TTS REMOVAL PLAN

Project Name: Iowa DOT, Bettenforf I-74 Temporary Relocation - Grant St to Mississippi Bridge Pier
 Scale: NONE

OSP Log: 82180401
 Drawing: 2 of 5
 Size: 11 x 17

ITS PLAN

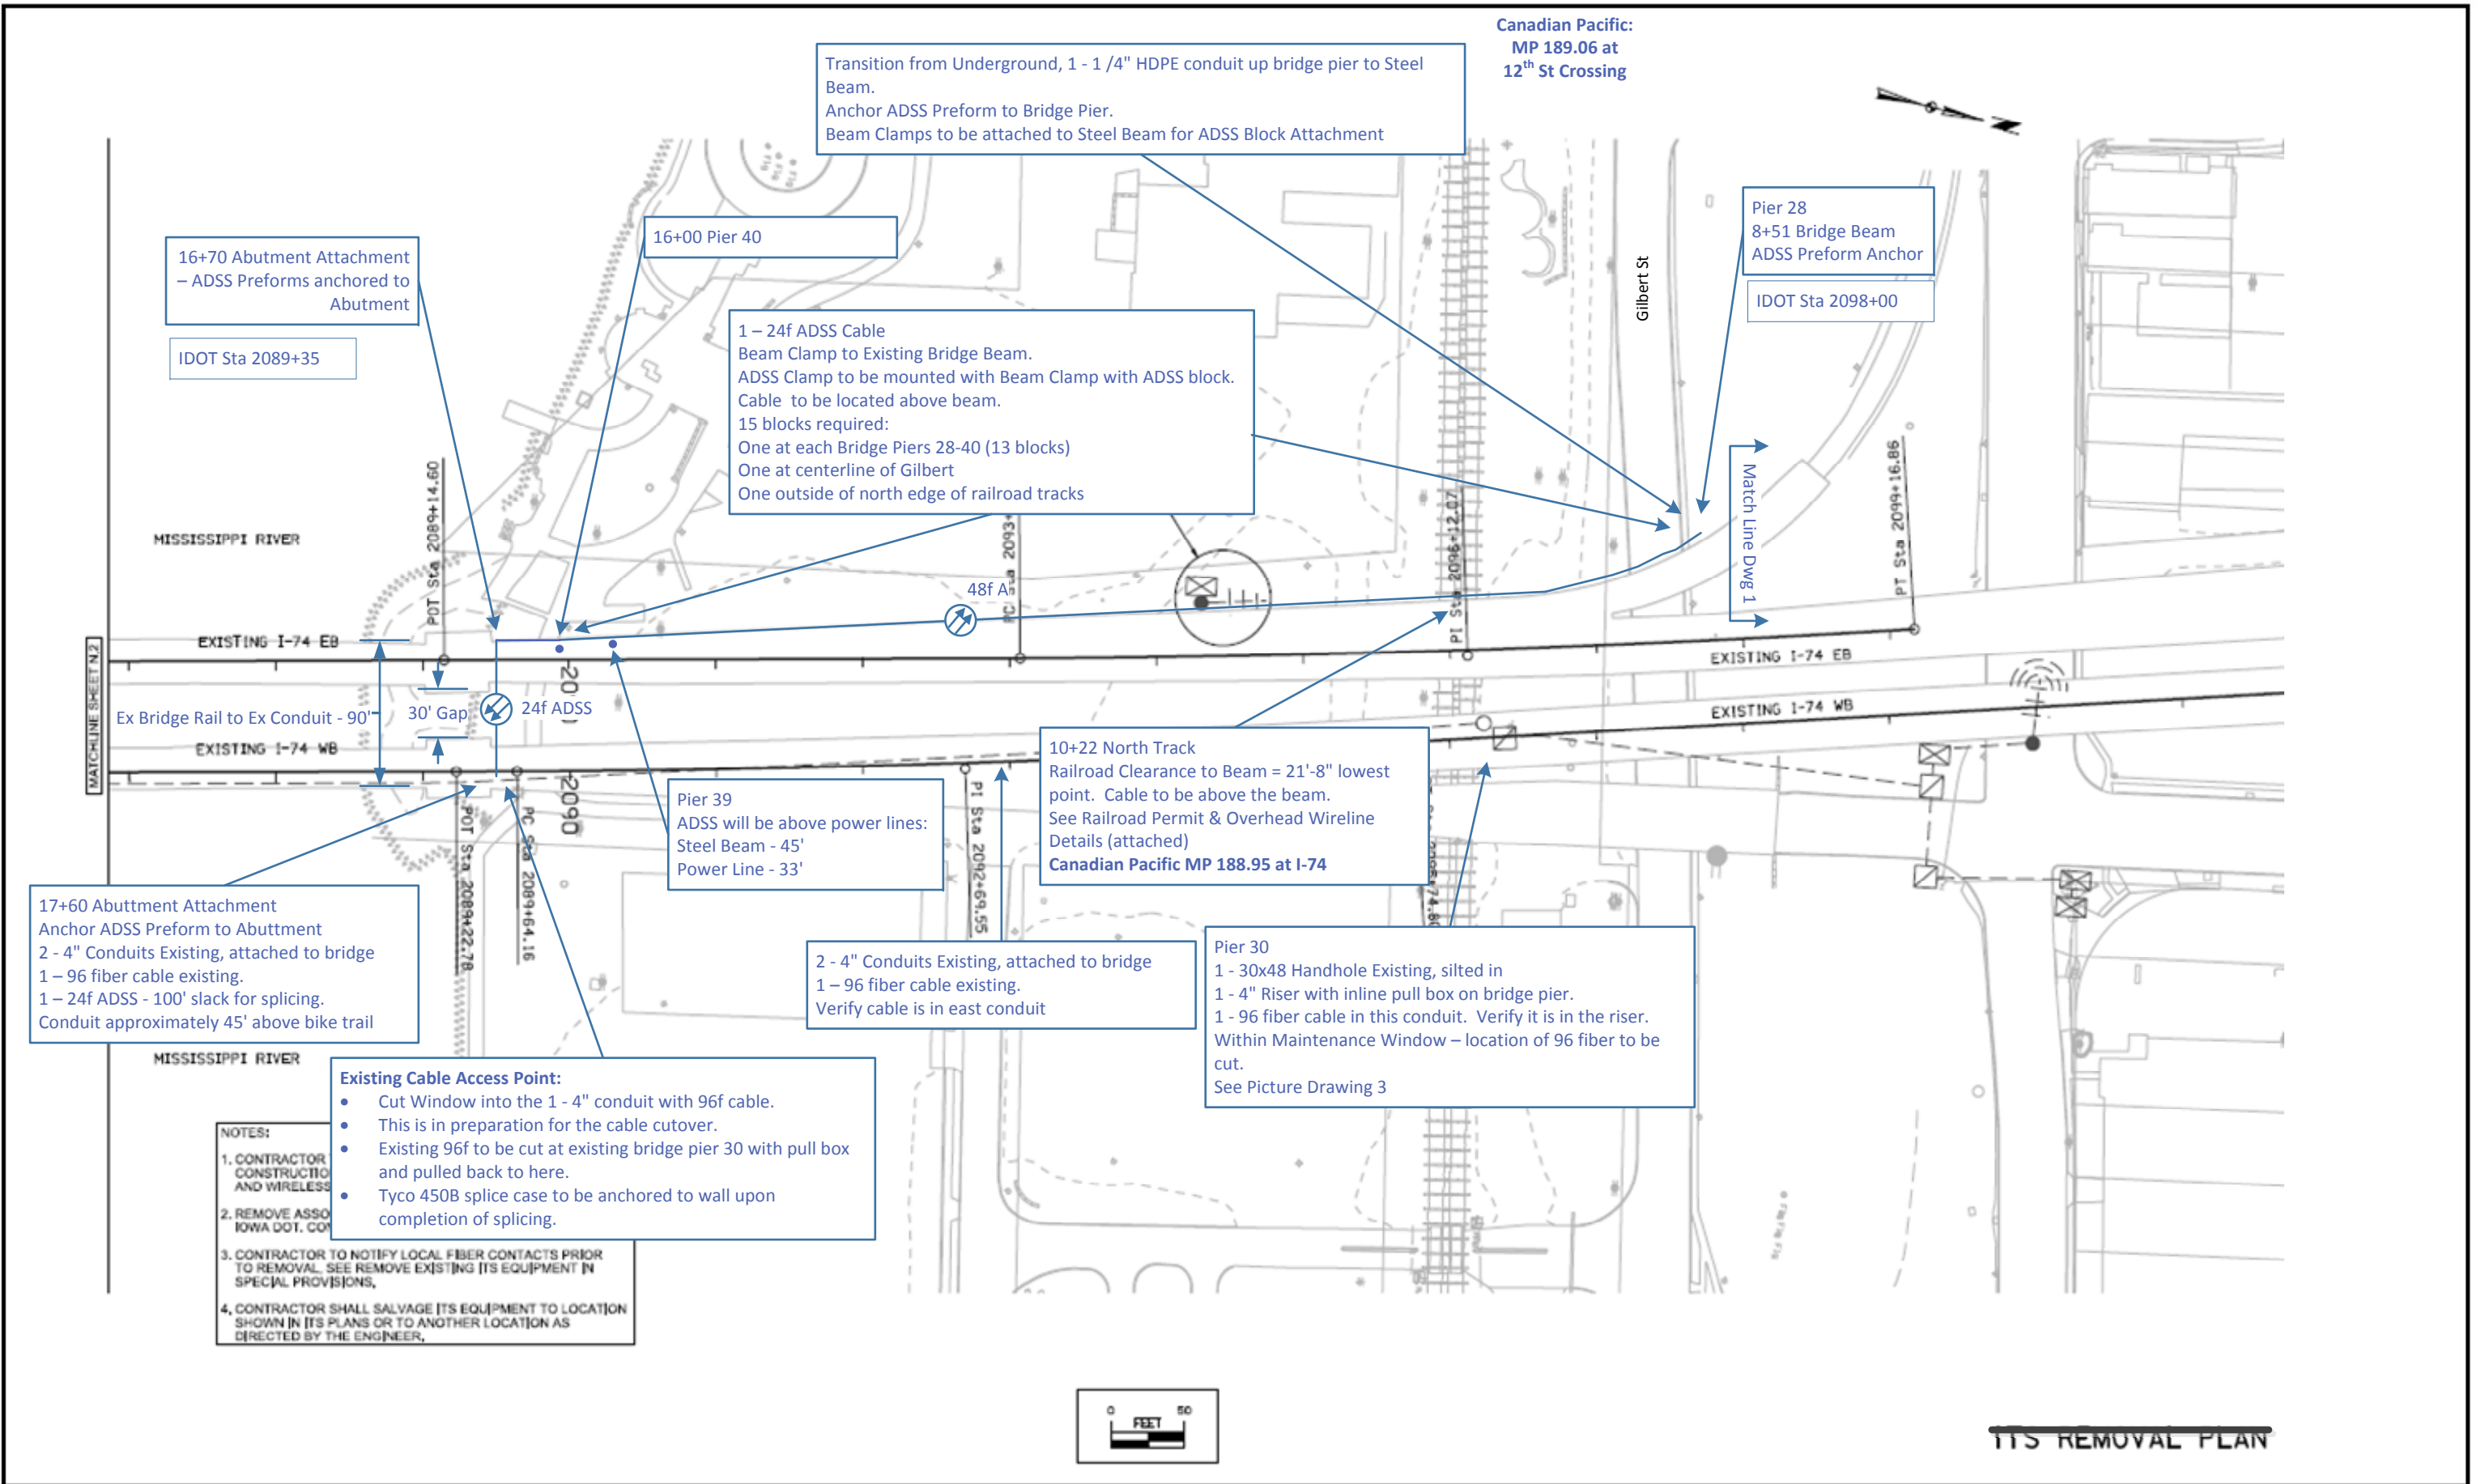
- Comments:**
 Blue Text is for Iowa DOT Temporary 24f ADSS Fiber Cable re-route.
- Army Corp of Engineers restrictions apply to levy and bike trail area; weight limit is restricted. Contractor will need to use an aerial lift (Genie or other) on the bike path and within restricted zone. See attached exhibit.

- Bike Path Closure is required; see referenced bike path re-route.
 - Bike Path Documentation – contractor shall take pictures or video to document the bike path pavement prior to and after completion of the work; pictures to be submitted. Any damage to pavement shall be restored by the contractor.

- Contractor is required to coordinate with Iowa DOT and Project Management on scheduling the cable placement within the work zone of IDOT Project 205.

- Site Contact: Jeff Koenig, HR Green 319.841.4312/319.538.2268 or Thomas McQuillan HNTB 312.771.8537.
 - Contractor shall attach the 24 fiber ADSS cable, to the existing bridge steel beam with beam clamps in order to mount ADSS blocks. Cable shall be above the beam.

- ADSS Cable Weight/KFeet = 65 lbs/1000'. Corning Solo 024EN4-T4M01A20 or equivalent.
 - Beam Clamps shall be Unistruct Model P2898 or P2899 or equivalent, hot dip galvanized (HDG) – dependent on beam thickness (contractor to verify).

- Concrete Anchors shall be either Hilti KWIK Bolt 3 Expansion Anchor, HDG or Hilti Drop in Anchor – Minimum 5/8".

Transition from Underground, 1 - 1/4" HDPE conduit up bridge pier to Steel Beam.
Anchor ADSS Preform to Bridge Pier.
Beam Clamps to be attached to Steel Beam for ADSS Block Attachment

1 - 24f ADSS Cable
Beam Clamp to Existing Bridge Beam.
ADSS Clamp to be mounted with Beam Clamp with ADSS block.
Cable to be located above beam.
15 blocks required:
One at each Bridge Piers 28-40 (13 blocks)
One at centerline of Gilbert
One outside of north edge of railroad tracks

10+22 North Track
Railroad Clearance to Beam = 21'-8" lowest point. Cable to be above the beam.
See Railroad Permit & Overhead Wireline Details (attached)
Canadian Pacific MP 188.95 at I-74

Pier 39
ADSS will be above power lines:
Steel Beam - 45'
Power Line - 33'

17+60 Abutment Attachment
Anchor ADSS Preform to Abutment
2 - 4" Conduits Existing, attached to bridge
1 - 96 fiber cable existing.
1 - 24f ADSS - 100' slack for splicing.
Conduit approximately 45' above bike trail

Pier 30
1 - 30x48 Handhole Existing, silted in
1 - 4" Riser with inline pull box on bridge pier.
1 - 96 fiber cable in this conduit. Verify it is in the riser.
Within Maintenance Window - location of 96 fiber to be cut.
See Picture Drawing 3

- Cut Window into the 1 - 4" conduit with 96f cable.
- This is in preparation for the cable cutover.
- Existing 96f to be cut at existing bridge pier 30 with pull box and pulled back to here.
- Tyco 450B splice case to be anchored to wall upon completion of splicing.

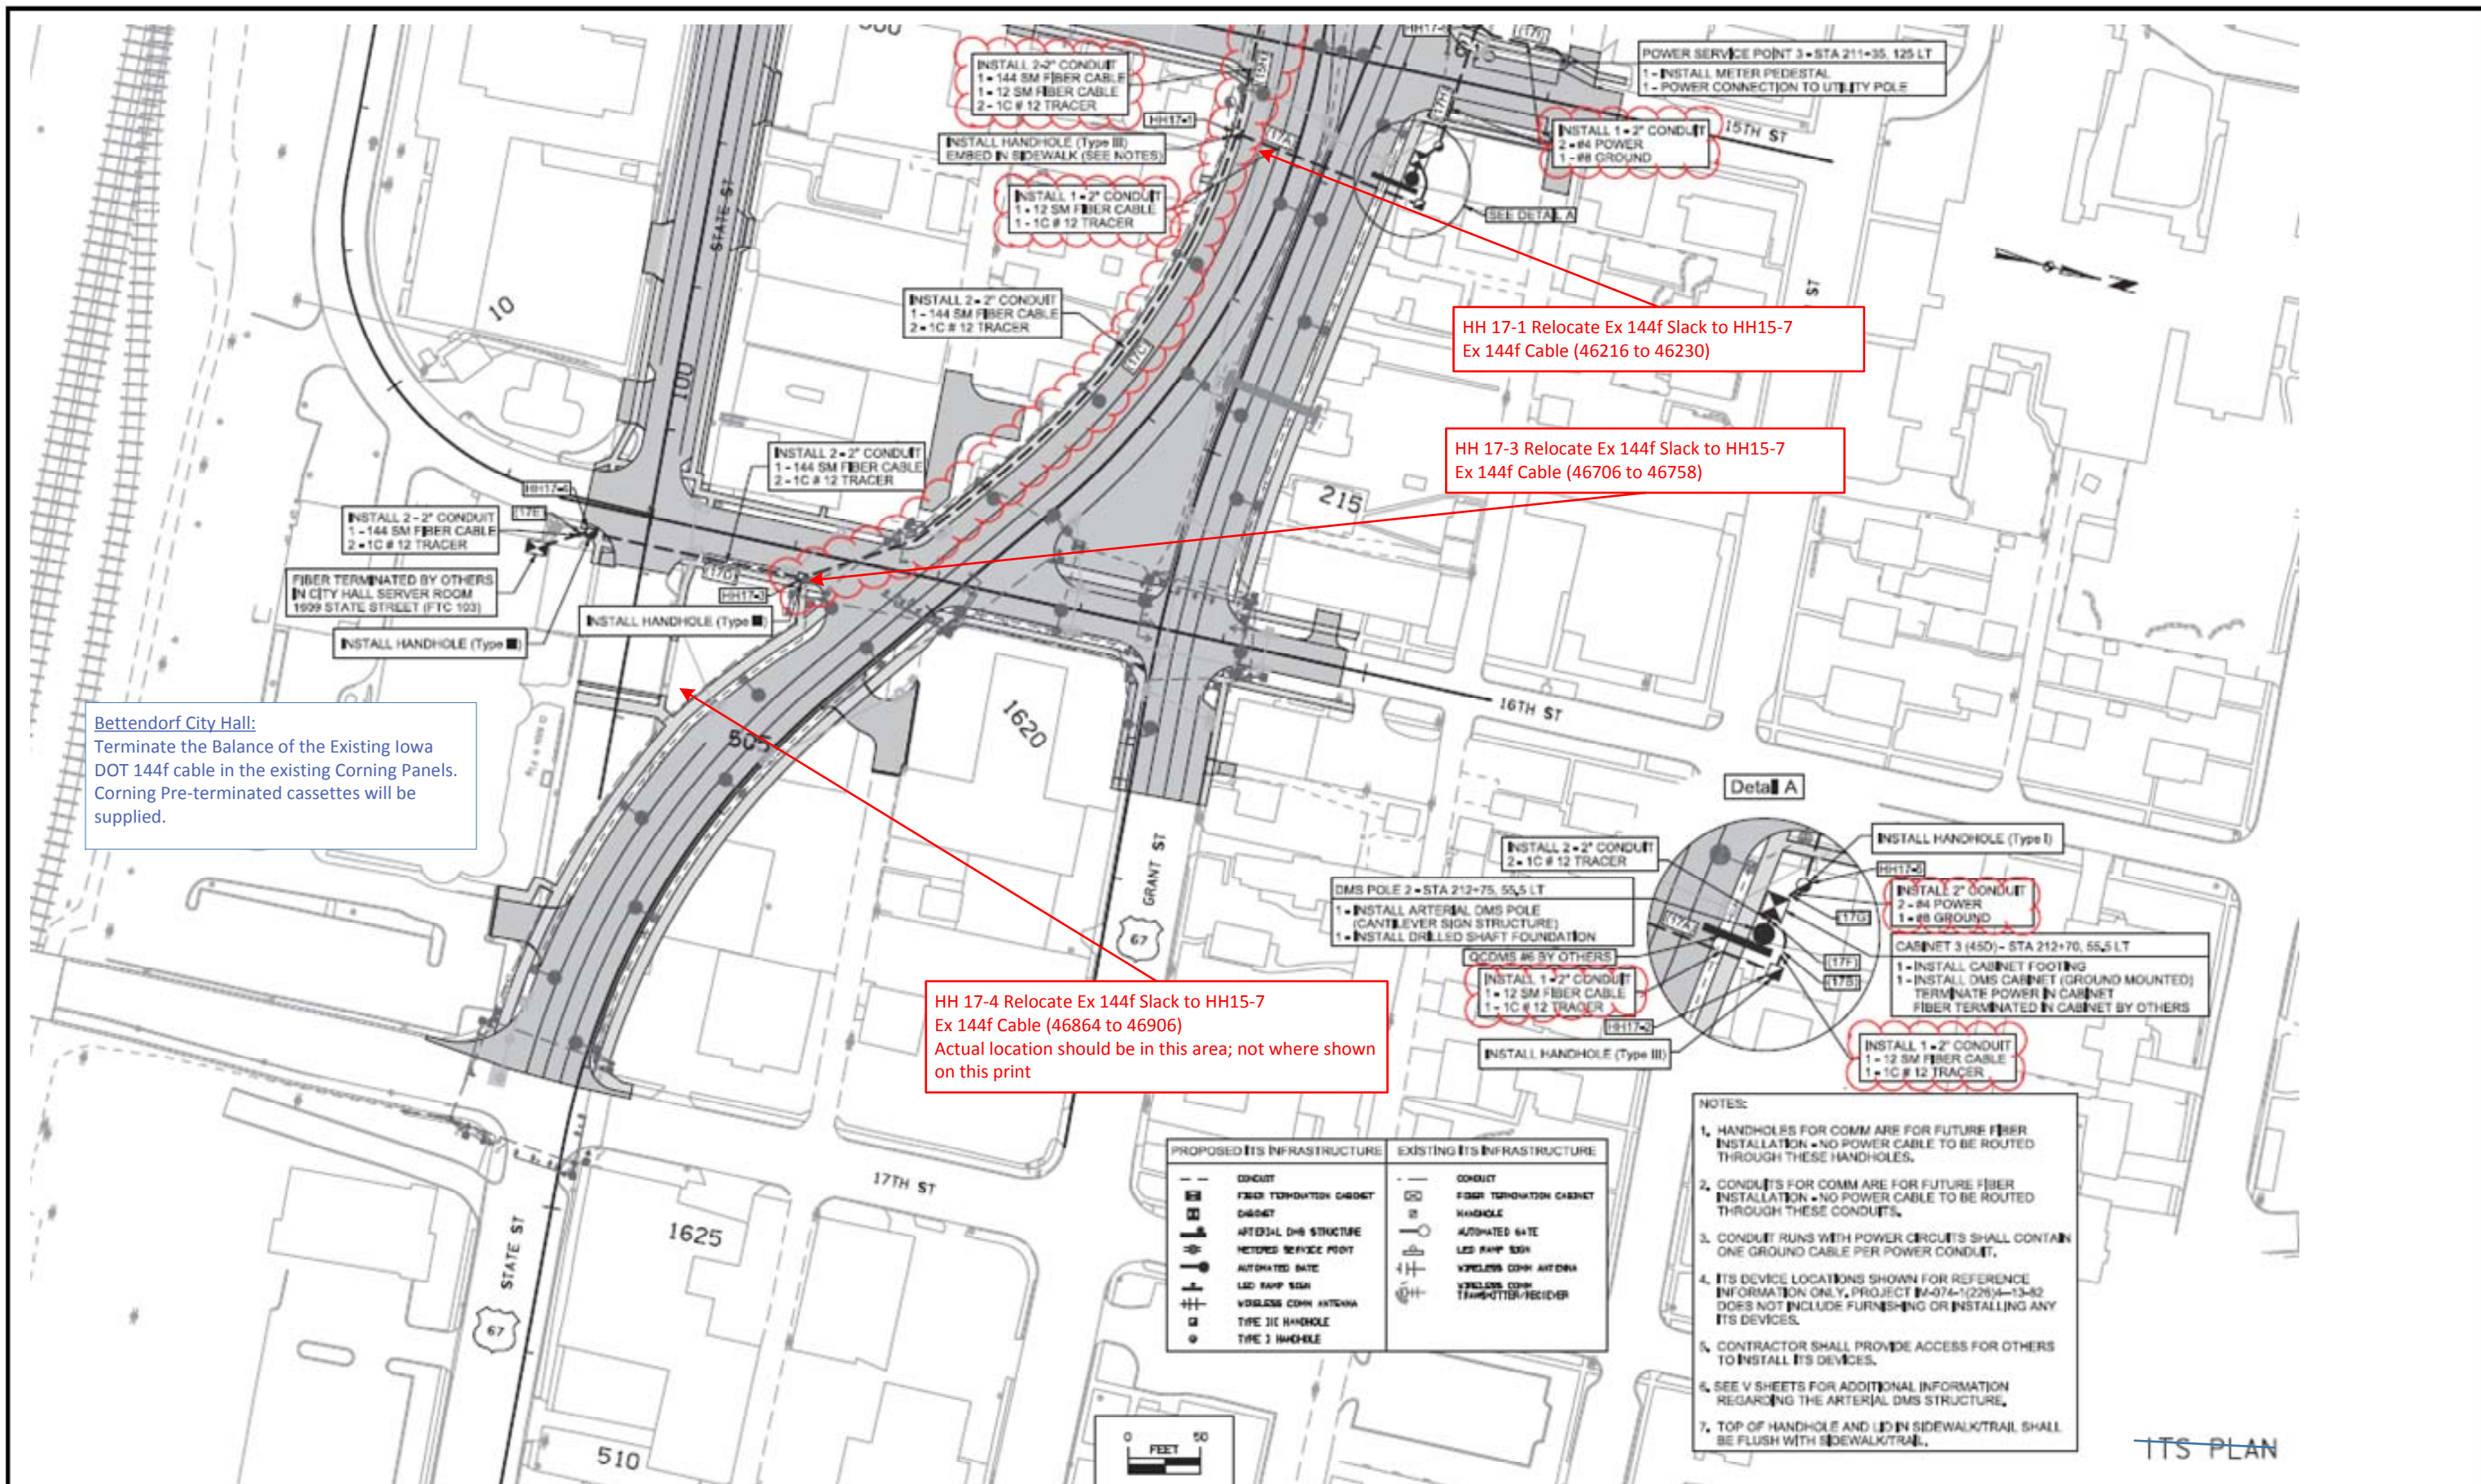
Bettendorf City Hall:
 Terminate the Balance of the Existing Iowa DOT 144f cable in the existing Corning Panels. Corning Pre-terminated cassettes will be supplied.

HH 17-1 Relocate Ex 144f Slack to HH15-7
 Ex 144f Cable (46216 to 46230)

HH 17-3 Relocate Ex 144f Slack to HH15-7
 Ex 144f Cable (46706 to 46758)

HH 17-4 Relocate Ex 144f Slack to HH15-7
 Ex 144f Cable (46864 to 46906)
 Actual location should be in this area; not where shown on this print

0+03 HH 15-7

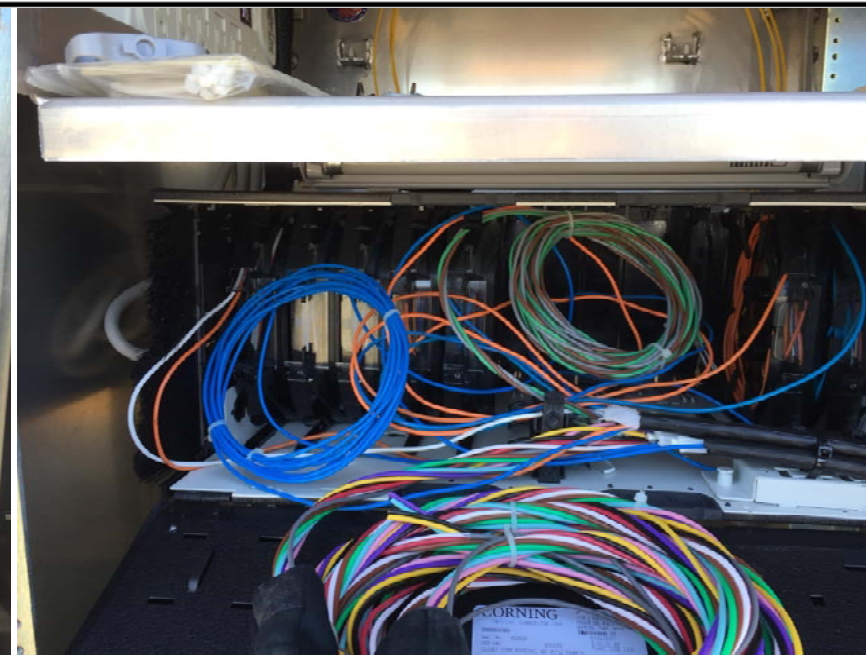
• Back of existing panel. Access no longer required.

• Ex 144f slack to be pulled back to this handhole.
 • New 24f ADSS – leave 75' of slack.
 • New Mid-Sheath on Ex. 144f to be installed.

8+13 to 8+48 to 8+51 Pier 28 Transition

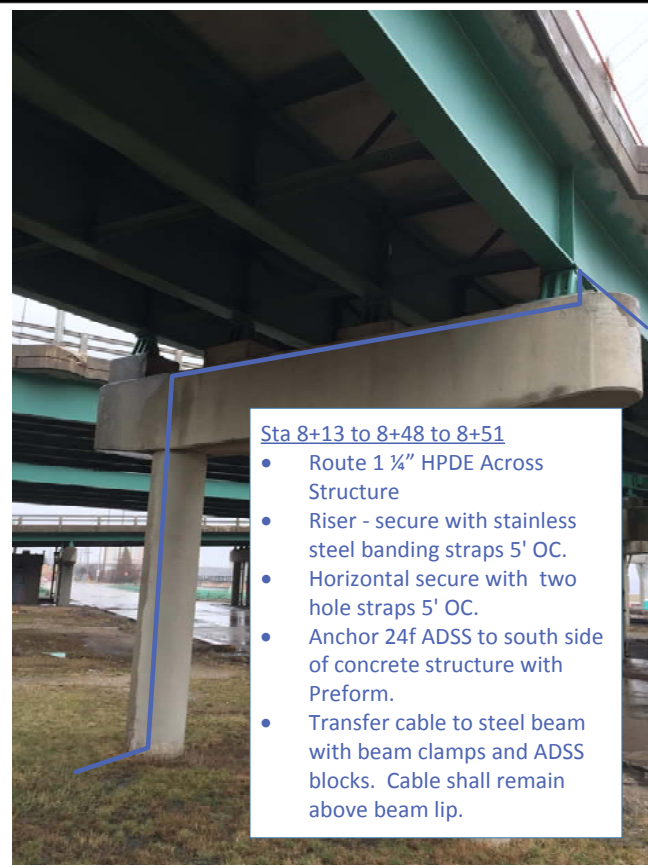
- Sta 8+13 to 8+48 to 8+51**
- Route 1 ¼" HPDE Across Structure
 - Riser - secure with stainless steel banding straps 5' OC.
 - Horizontal secure with two hole straps 5' OC.
 - Anchor 24f ADSS to south side of concrete structure with Preform.
 - Transfer cable to steel beam with beam clamps and ADSS blocks. Cable shall remain above beam lip.

1-24f ADSS mounted with beam clamps / cable to stay above bottom of the beam

21'-8" Bottom of Beam to Top of Rail Cable to be located above the Beam

Place Beam Clamp/ADSS Block above each concrete pier and 5' outside of north edge of tracks.

Pier 39 – ADSS above Power Lines

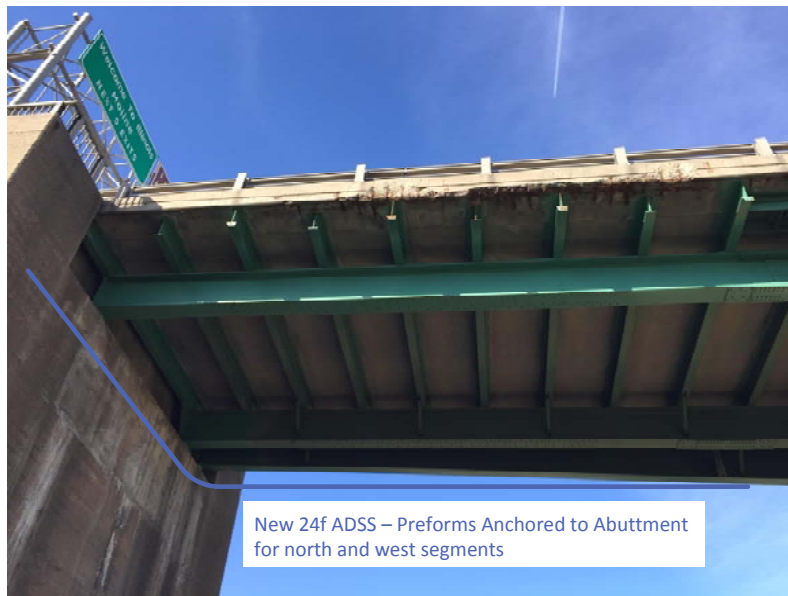
New 24f ADSS – Preforms Anchored to Abutment for north and west segments

16+70 West Abutment – New Aerial Attachment

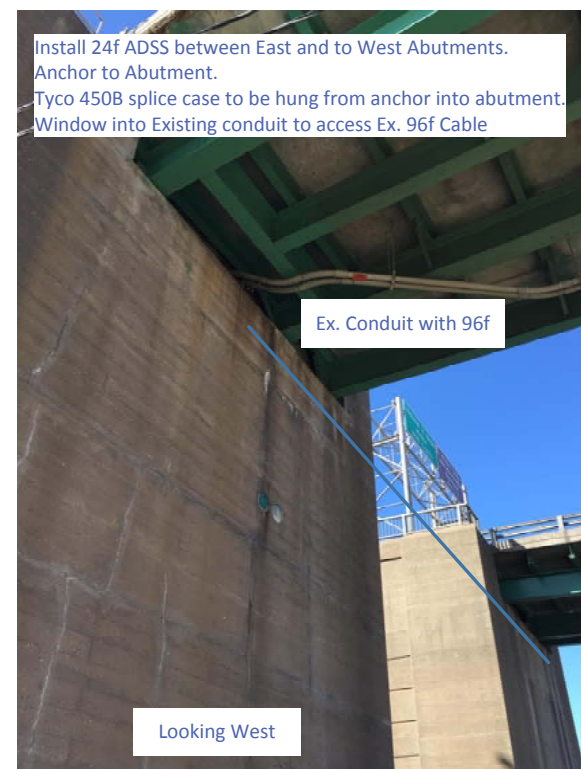
Install 24f ADSS between East and to West Abutments. Anchor to Abutment. Tyco 450B splice case to be hung from anchor into abutment. Window into Existing conduit to access Ex. 96f Cable

Install 24f ADSS between East and West Abutments. Anchor to Abutment. Tyco 450B splice case to be hung from anchor into abutment. Window into Existing conduit to access Ex. 96f Cable
